CITY OF ALBUQUERQUE

Re: ABQ School of Excellence Charter School 13201 Lomas Blvd., NE Traffic Circulation Layout Engineer's/Architect's Stamp 6-28-16 (J22-D050)

Based upon the information provided in your submittal received 7-1-16, the above referenced plan cannot be approved for Building Permit until the following comments are addressed:

TRAFFIC CIRCULATION LAYOUT PLAN

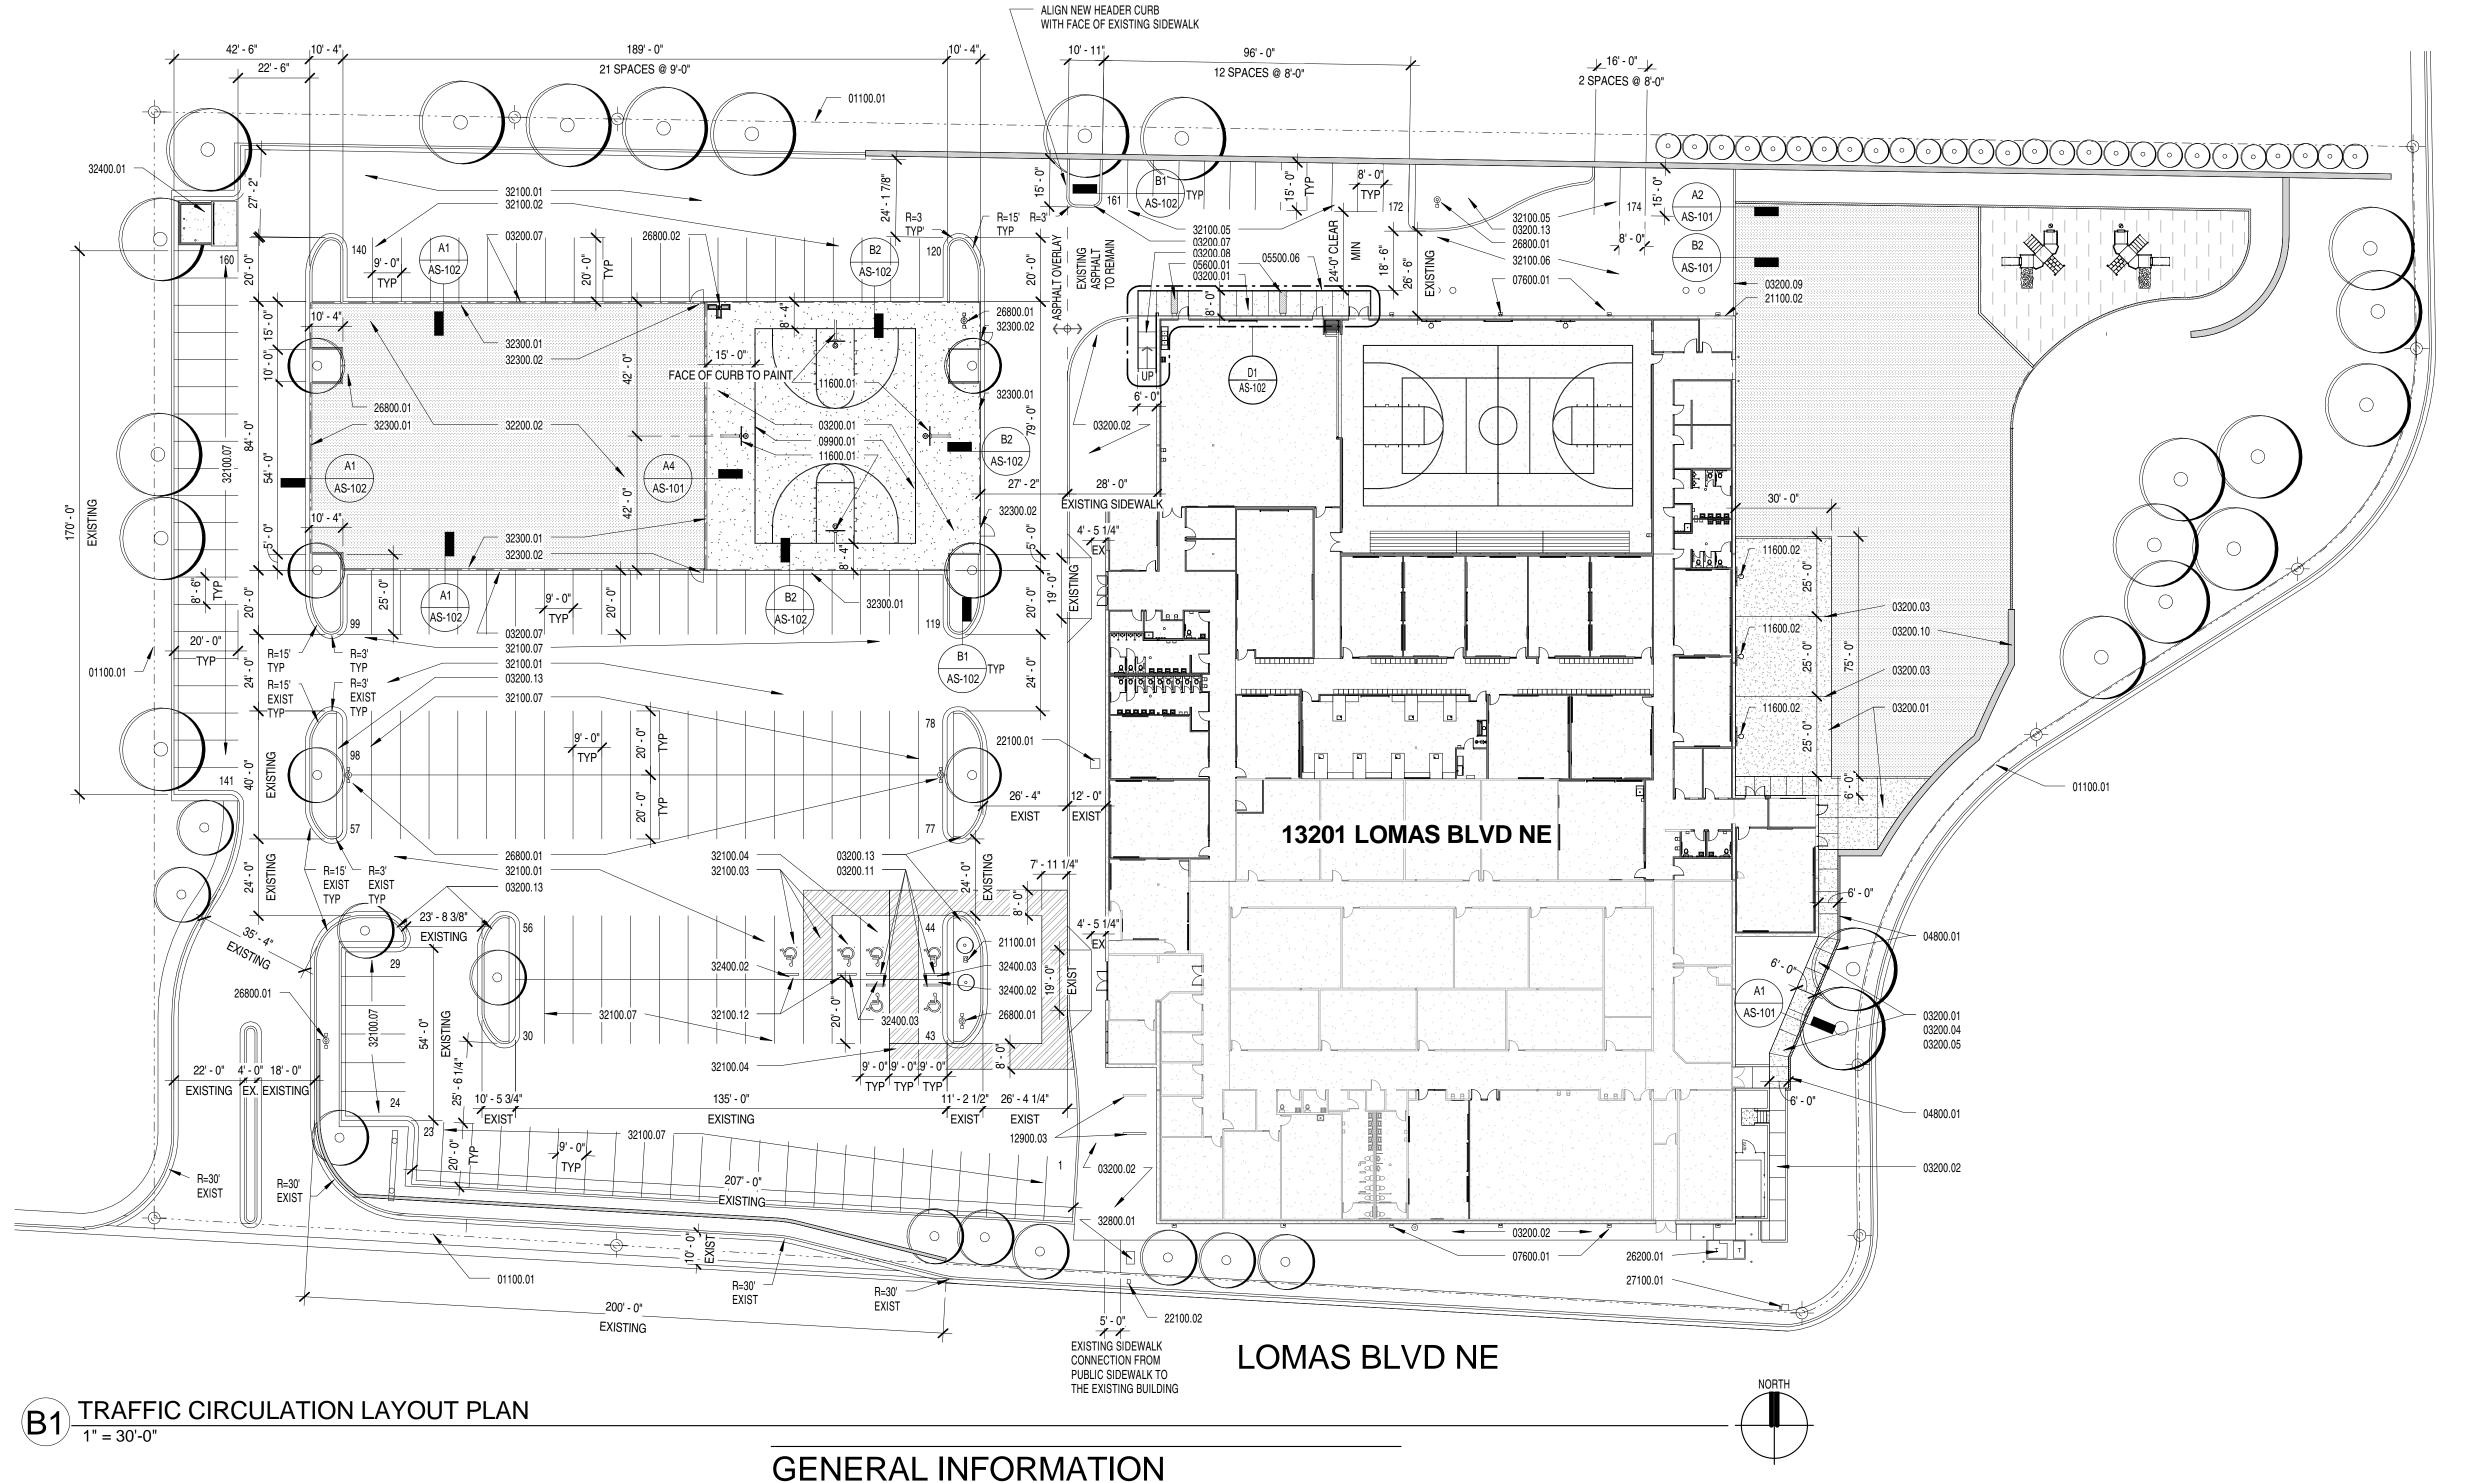
- 1. Please identify all existing buildings, doors, sidewalks, ADA ramps, curbs, drive pads, wall and anything that influences the parking and circulation on the site.

- 2. Please call out ADA ramps and truncated domes on drive pad crossings, which are required at all public ROW crossings.
- 3. Identify all existing access easements and rights of way width dimensions.

- 4. Identify the right of way width, medians, curb cuts, and street widths on Lomas Blvd. and Tramway Service Rd. Please detail the drive pad width north of the entrance off of Lomas Blvd..

- The handicap accessible spaces must be a minimum of 8.5 ft. in width.
- 6. The handicap accessible spaces must include an 8 ft. wide van access aisle; all other aisles should be 5 ft. in width.

- 7. The ADA accessible parking sign must have the required language per 66-7-352.4C NMSA 1978 "Violators Are Subject to a Fine and/or Towing." Please call out detail and location of HC signs.

- 8. The ADA access aisles shall have the words "NO PARKING" in capital letters, each of which shall be at least one foot high and at least two inches wide, placed at the rear of the parking space so as to be close to where an adjacent vehicle's rear tire would be placed. (66-1-4.1.B NMSA 1978)

- Per DPM, a 6 ft. wide ADA accessible pedestrian pathway is required from the public sidewalk to the building entrances. Please clearly show this pathway and provide details. In review of the submitted drawing, the proposed ADA access from the ROW is 5 ft. in width.

- 10. Per DPM, a 6 ft. wide ADA accessible pedestrian pathway is required from the HC parking stall access aisles to the building entrances. Please clearly show this pathway and provide details. It not permissible to have the ADA access isle from the HC parking guide pedestrians behind parking spaces in order to enter building.

- 11. Provide a min 6" or max 8" high concrete barrier curb or other acceptable barrier between landscaping and parking areas and/or drive aisles. Please call out detail and location of barrier curb.

- Service vehicle and/or refuse vehicle maneuvering must be contained on-site; provide a copy of refuse approval.
- 13. One-way vehicular paths require pavement directional signage and a posted "Do Not Enter" sign at the point of egress. Please show detail and location of

- 14. Please provide a sight distance exhibit (see the *Development Process Manual*, *Chapter 23, Section 3*). Please show this detail for the entrance/exit on Lomas Blvd.

- 15. Please add the following note to the clear sight triangle: "Landscaping and signage will not interfere with clear sight requirements. Therefore, signs, walls, trees, and shrubbery between 3 and 8 feet tall (as measured from the gutter pan) will not be acceptable in this area."

- 16. Please add a note on the plan stating "All improvements located in the Right of Way must be included on the work order."
- All broken or cracked sidewalk must be replaced with sidewalk and curb & gutter. A build note must be provided referring to the appropriate City Standard drawing.
